Global Programme to Support Countries with the Shift to Electric Mobility - Addendum

Review PIF and Make a recommendation

10544

PFD

Fig. 3. GHG emissions due to the use of electric vehicles in the European Union.

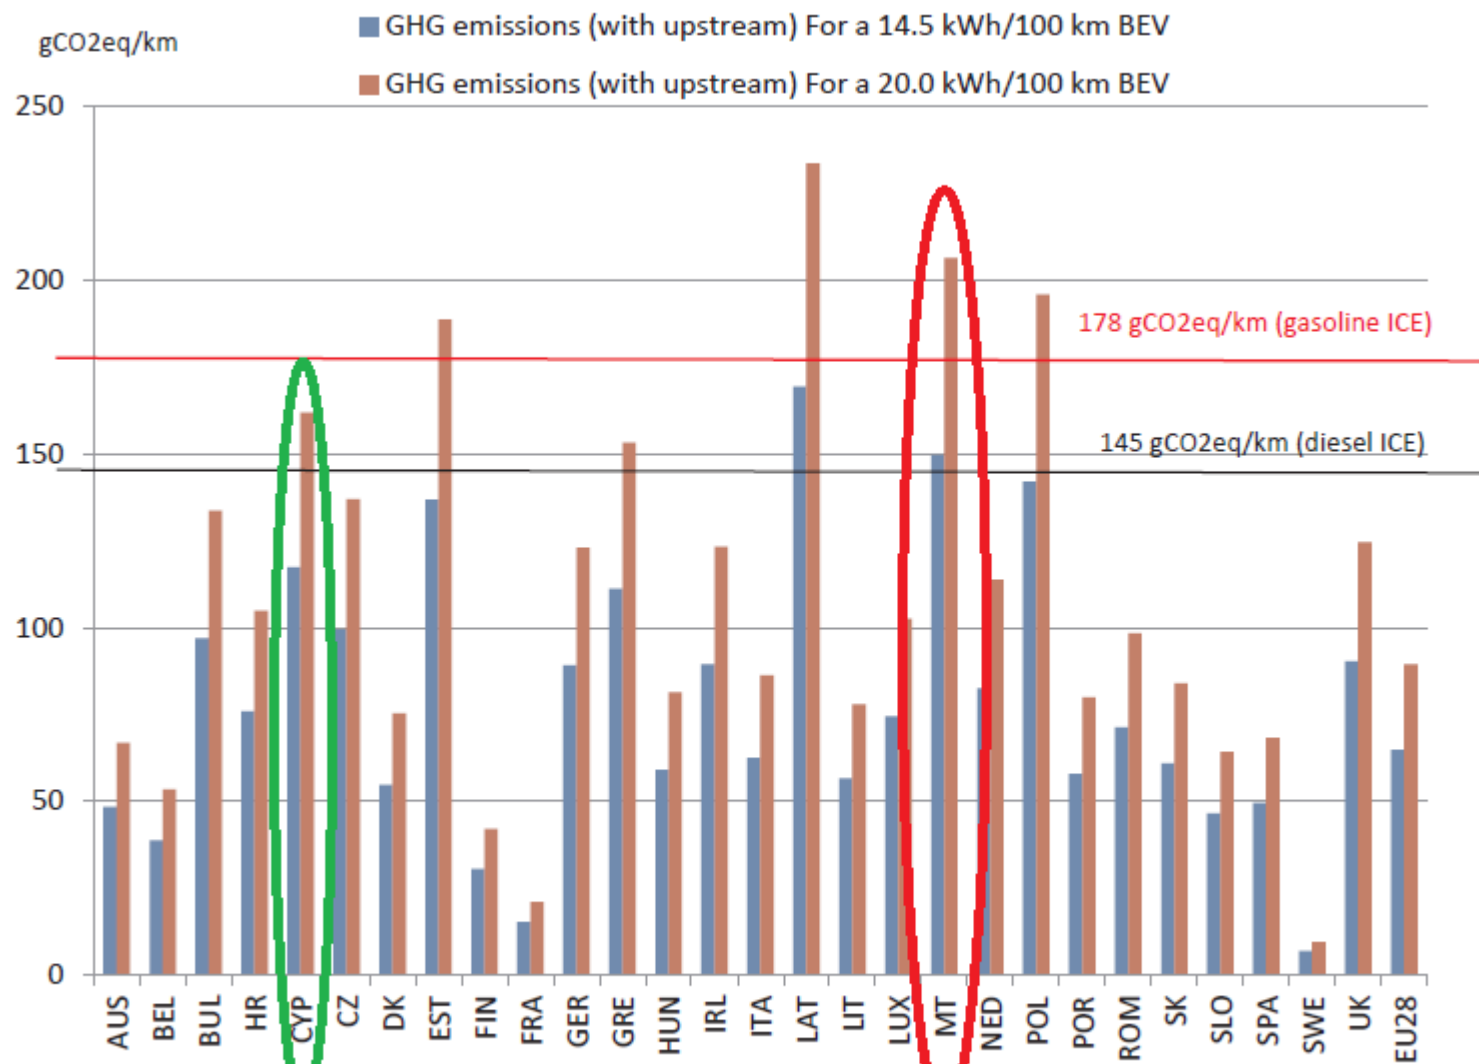
This intended change in carbon intensity of grid electricity is essential for any electric mobility project in South Africa, since the carbon intensity of today's grid power leads to increased GHG emissions from an electric vehicle compared to a conventional one. In 2015, the transport sector accounted for about 13% of energy related CO₂ emissions, with road transport being responsible for more than 90% of all transport emissions (Figure 2).

It is generally recognized that even in high carbon intensity grid countries, EV are more efficient than ICE in terms of emissions per kilometers. Please include a reference/additional info for this sentence or remove it.

Along the same lines goes the following statement:

Since South Africa has one of the highest grid electricity carbon footprint worldwide, in the near future significant CO₂ emission reductions can only be achieved if the carbon footprint of the electricity used to charge the buses is at least 30% lower than the average grid. This is why the demonstration projects will seek for ways to use lower carbon footprint electricity for example based on agreements with renewable power producers to buy their electricity either for direct use to charge the e-buses, or by off-setting emissions elsewhere in the grid.

Please confirm if there is available literature that has established that ICEs have less emissions than EVs powered with SA grid electricity?

Please note that the Indonesian child project makes for the opposite argument, stating that even in high carbon emission factor countries EV still make sense in terms of emission reductions, both immediately due to economies of scale and higher efficiency of electric drive, as well as "future-proofing" of future RE addition to the grid that will be able to be capitalized by existing EVs.

3. The statement has been removed.

Although both the South African as well as the Indonesian grid would qualify as high carbon intensive, there are significant differences between the two countries. While South Africa has a carbon intensity of about 1kg CO₂ per kWh grid electricity, the Indonesian grid power has a carbon content of about 870 g CO₂ per kWh. While in South Africa electric vehicles would generate more emissions than conventional vehicles without efforts on renewable energy integration, in Indonesia electric vehicles would emit less CO₂ than conventional vehicles.

Recognizing that additional renewable energy needs to be included in South Africa to reduce emissions with the introduction of electric vehicles, the South African project aims at including a 30% renewable energy share in the electricity mix used for charging the demonstration buses. As shown in Figure 1 of the South Africa concept note, under all scenarios (IRP2 to IRP4) tested in the South African Integrated Resources Plan (2018), the share of coal in the power mix will be reduced by approximately 50% (from currently 81% of the total electricity production to around 40%) by 2040. The reduction in coal-based power production will be replaced almost entirely by renewable energies (wind, solar PV, CSP and hydro). This gradual increase in the share of renewable power generation in the South Africa's energy mix will therefore contribute to the reduced CO₂ emissions stemming from the electric vehicles – and this was also considered when estimating the GHG emission reductions for the South Africa e-mobility proposal. Please also refer to our responses to comment No. 3 in the section 6. of the review sheet dedicated to “contributions to global environmental benefits” further down.

Please also see analysis from EU JRC on EV emission mitigation within various EU grids (Electricity carbon intensity in European Member States: Impacts on GHG emissions of electric vehicles, Alberto Moro, Laura Lonza European Commission, Joint Research Centre (JRC), Via Enrico Fermi 2749, 21027 Ispra (VA), Italy, <https://www.sciencedirect.com/science/article/pii/S1361920916307933>). Data from Cyprus and Malta, which respectively have similar grid emission factors to Indonesia and South Africa, respectively, show the impact of the grid emission difference on GHG emission savings from EVs.
